SNOHOMISH COUNTY DEPARTMENT OF PUBLIC WORKS	CHANGE ORDER JUSTIFICATION	CHANGE ORDER NUMBER
		5
		2/11/2022
		Page 1 of 45

PROJECT:	**Index-Galena Road Flood Repair**	**PROJECT #:**	**RC1532, RC1774, RR6322**
PROJECT ENGINEER:	**Sam Chi**	**FED AID #:**	**ER-0701(063)**

This Change Order revises plan sheet details associated with Compost Amended Vegetative Filter Strip (CAVFS), gravel shoulder/ditch transitions, and guardrail at multiple locations. The following plan sheets will be replaced as part of this change order: TS01, TS02, TS03, TS05, TS06, PP06 through PP11 and MS04.

Revised CAVFS Detail

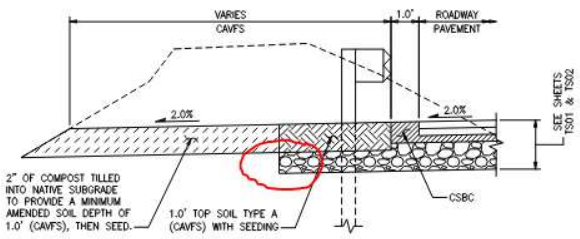
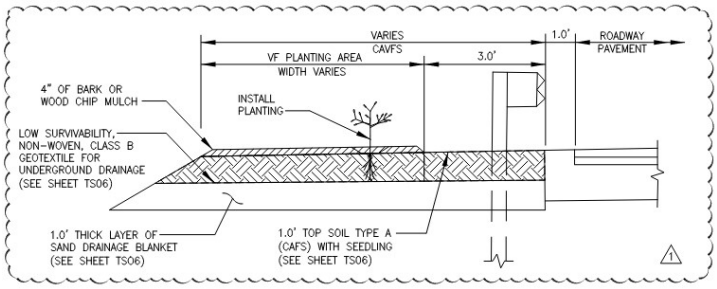
3. Subgrade Drainage: At multiple locations where CAVFS will be constructed, the roadway section details show a step up in the subgrade. With a uniform 2% cross-slope to the left, this could potentially lead to drainage issues and compromise the integrity of the roadway pavement. Plan changes were made to improve subgrade drainage by modifying the CAVFS detail. A sand drainage blanket layer under Topsoil Type A and geotextile fabric will provide positive drainage away from the roadway base.
